ERI/NRC 95-103

**TECHNICAL EVALUATION REPORT OF THE
SHEARON HARRIS INDIVIDUAL PLANT EXAMINATION
BACK-END SUBMITTAL**

Final Report

May 1995

Figure 1 Frequency of Exceedance of Iodine Release

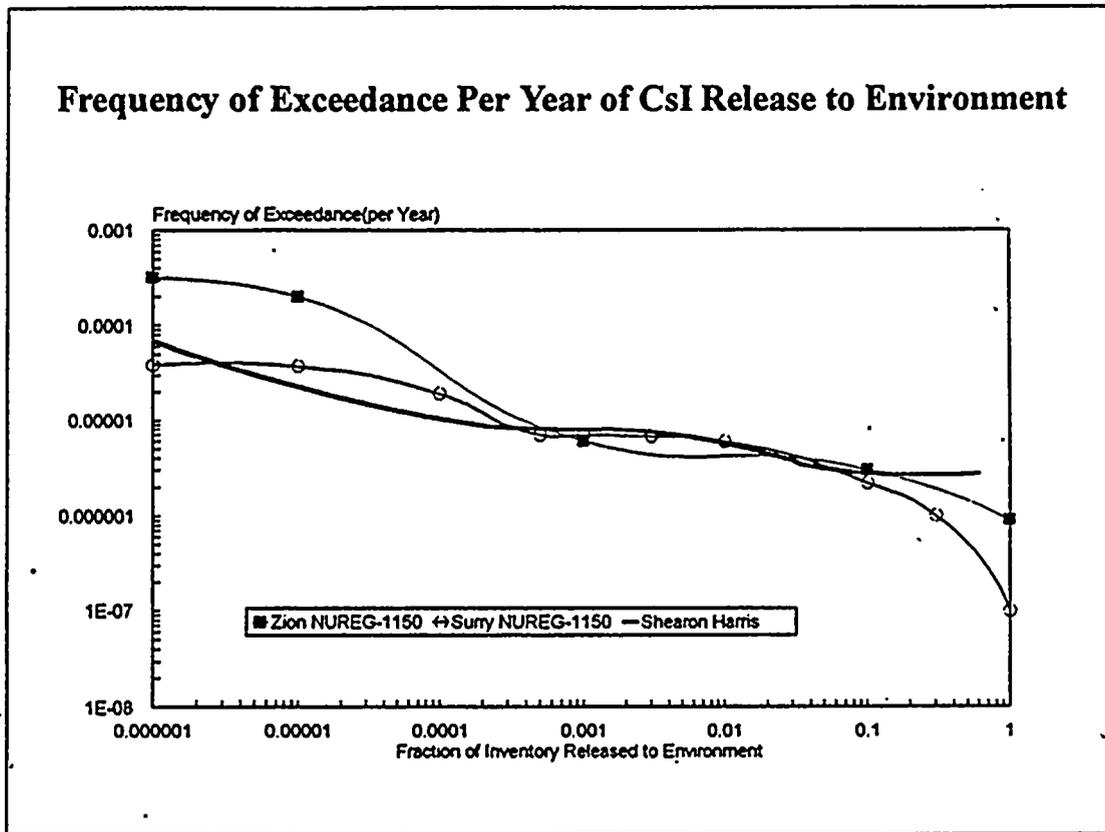
Figure 1 shows a plot of the frequency of exceedance of iodine release as a function of the fraction of inventory released to the environment. The results for the Surry and Zion plants from the NUREG-1150 analysis are also plotted in the same figure. However, it can be seen that the release profile for the Shearon Harris plant is quite different than that of the other two plants, since it is dominated by steam generator tube rupture sequences.
